WATER SYSTEM IMPROVEMENTS PROJECT

ADDENDUM # 1

**WVIJDC NO. 2018W-1766
THRASHER PROJECT NO. 101-010-1141**

SHEET No.
10

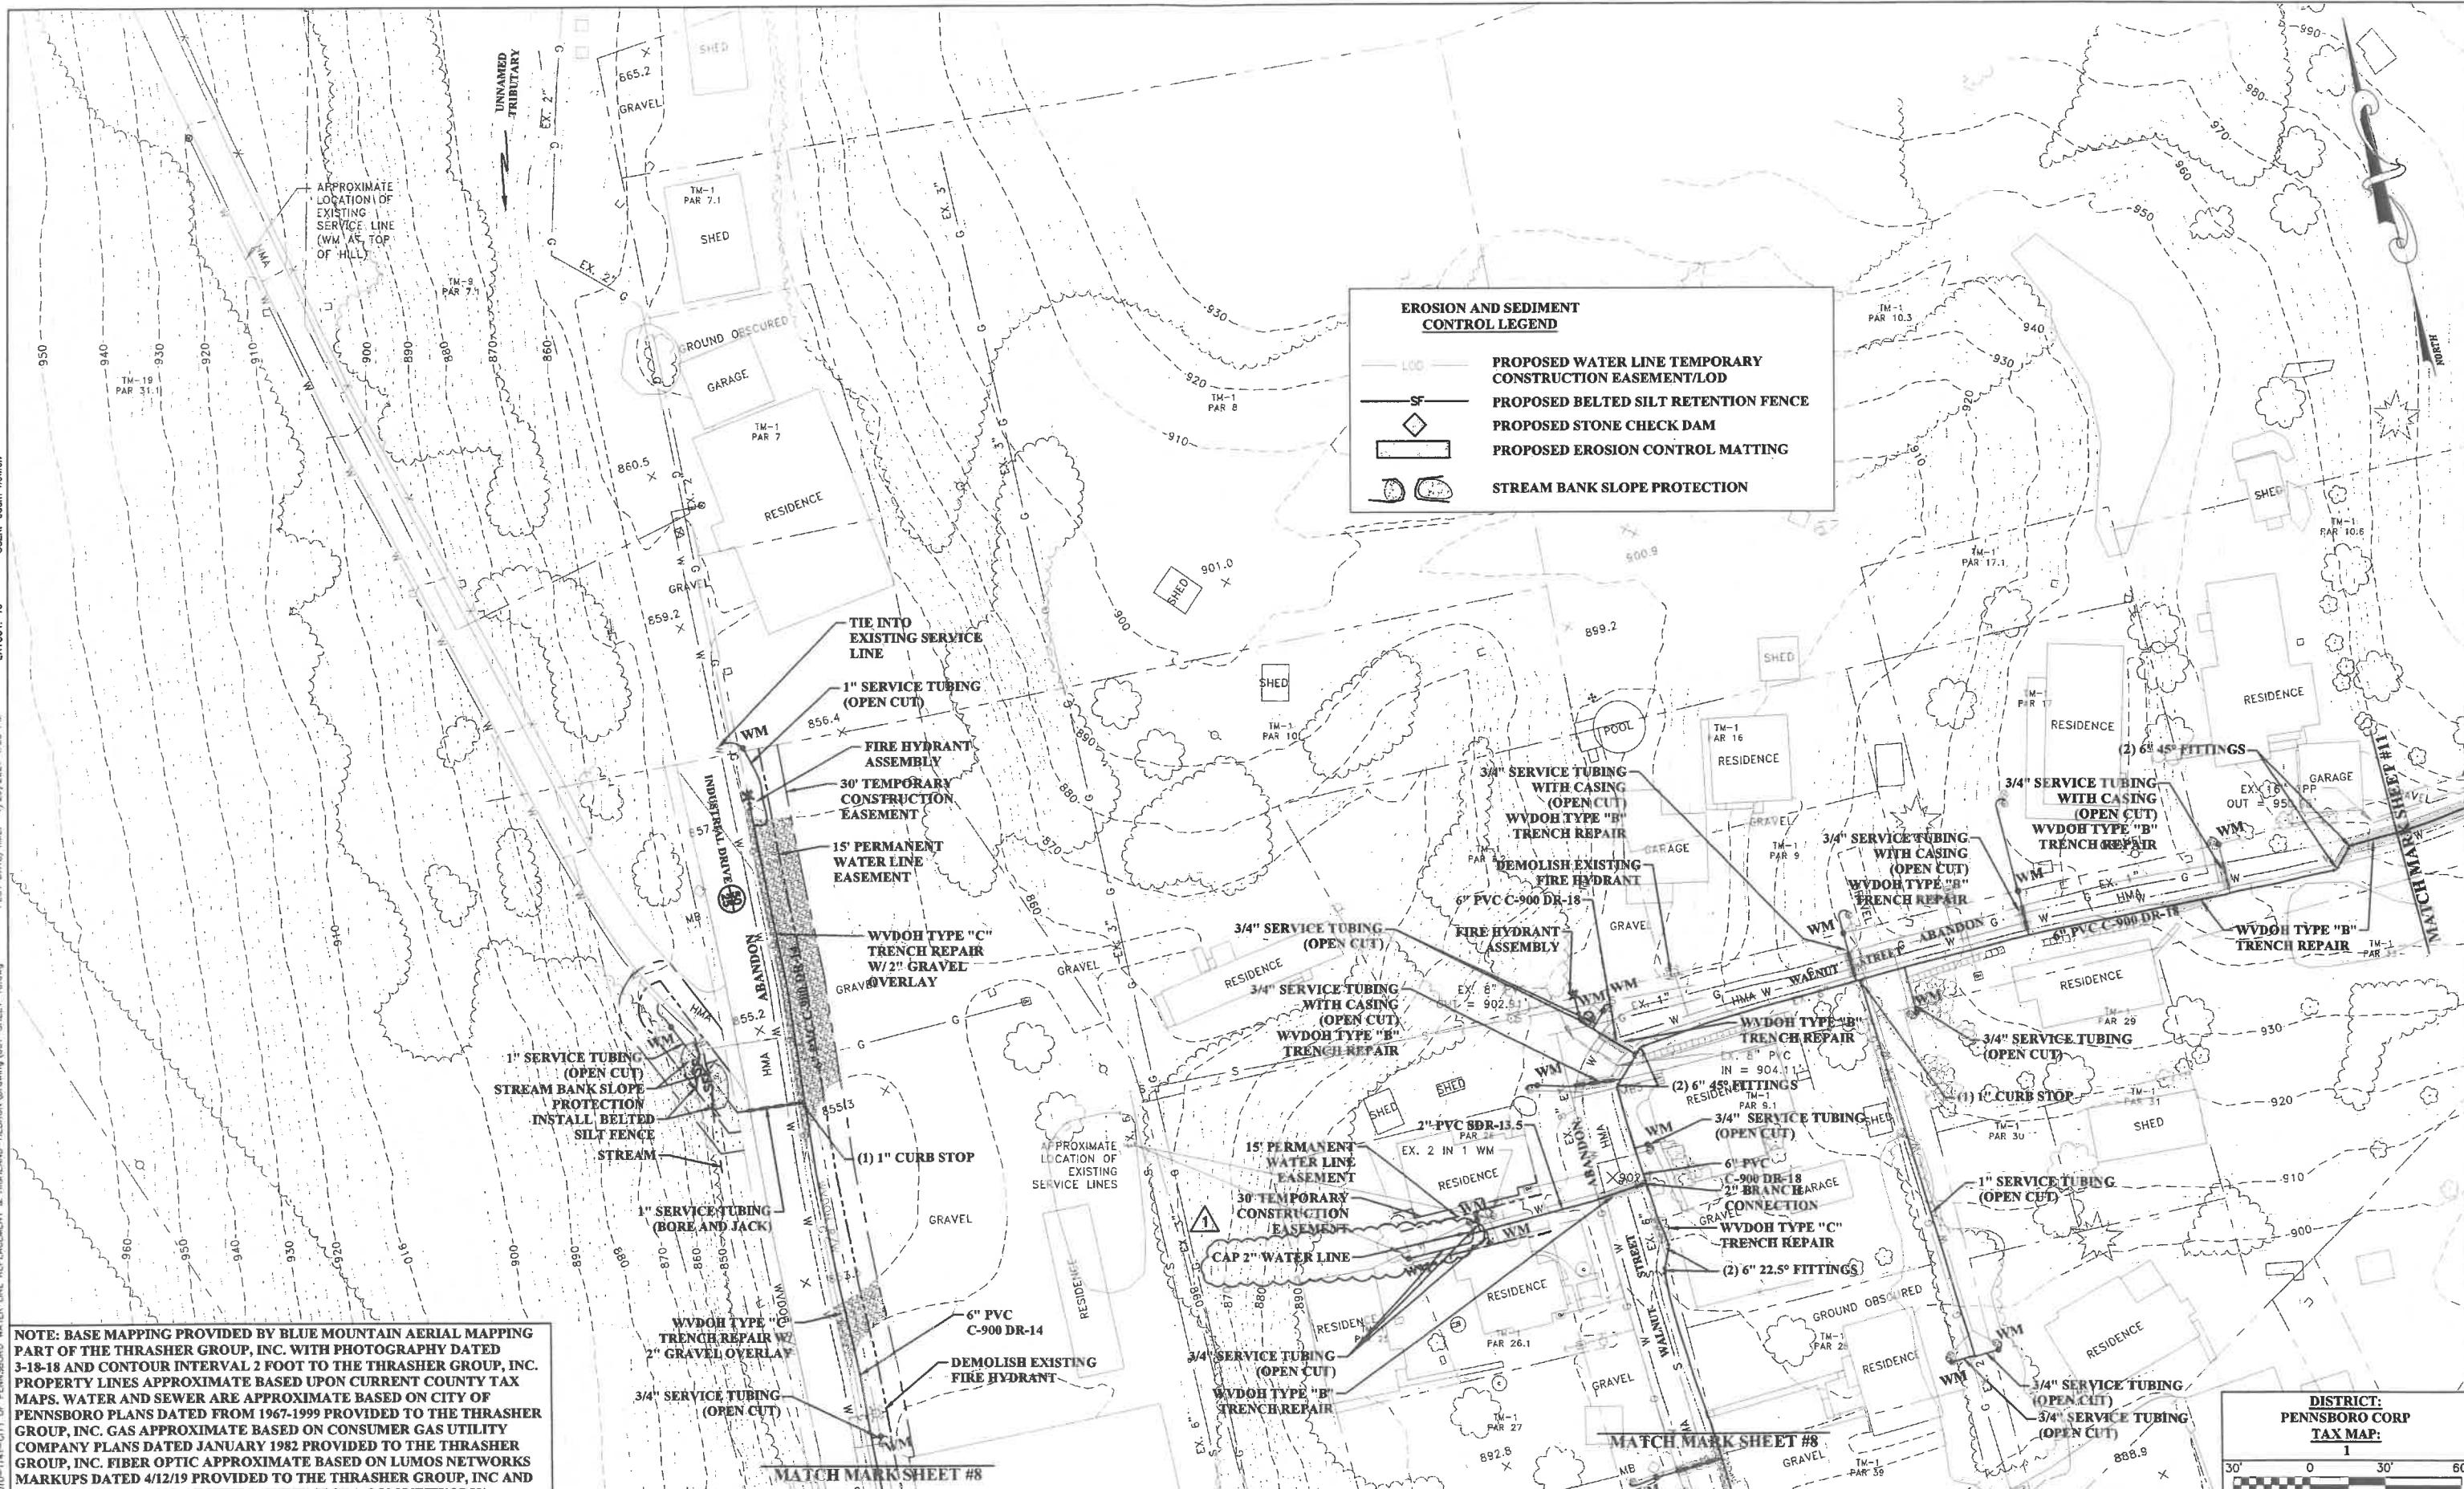
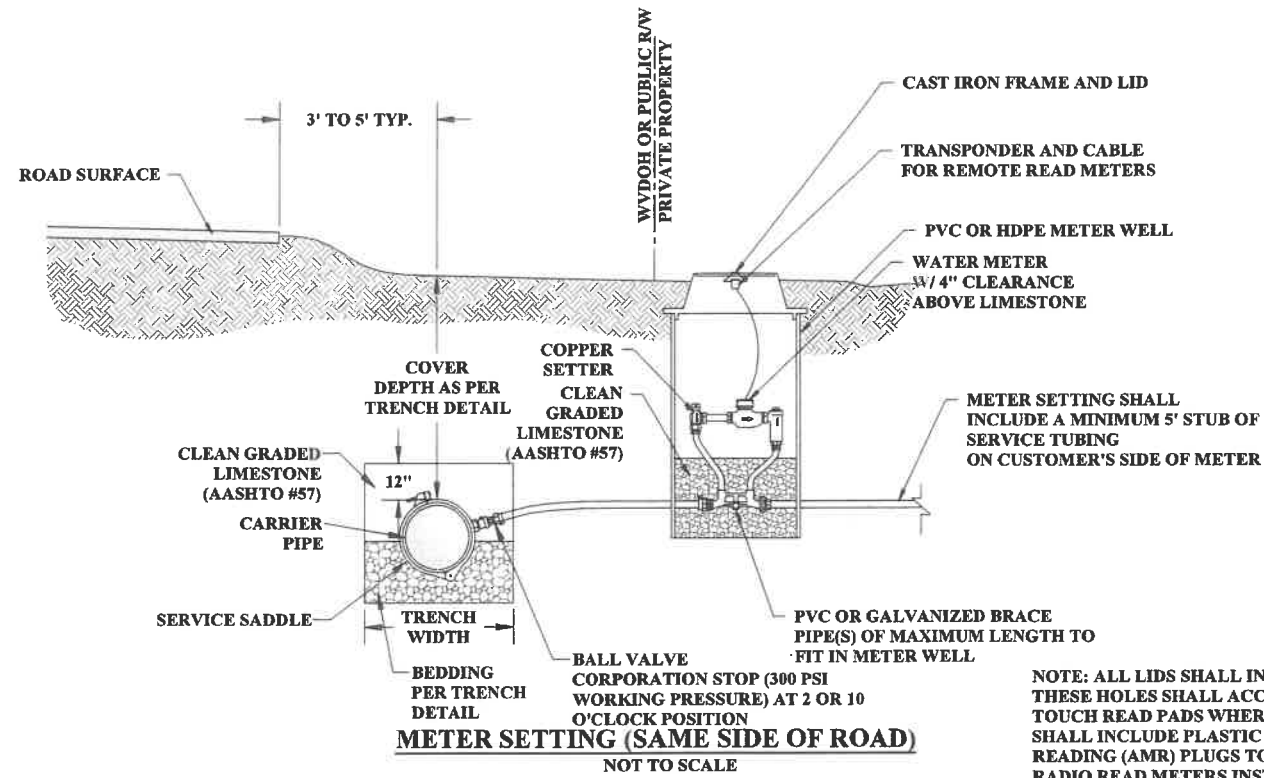
1. Plan Sheet 10 has been revised removing the post flushing hydrant. See Revised Plan Sheet 10 included with this Addendum #1.
2. The RECONNECTION DETAIL WITH EXISTING WATER METER AT OR NEAR PROPERTY LINE shown on Plan Sheet D7 has been modified. See Revised Plan Sheet D7 included with this Addendum #1.

| NO. | BY | DATE | DESCRIPTION |
|-----|----|----------|---|
| 1 | AN | 04/29/21 | ADDENDUM - REMOVED FLUSHING HYDRANT AND ADDED CAP |
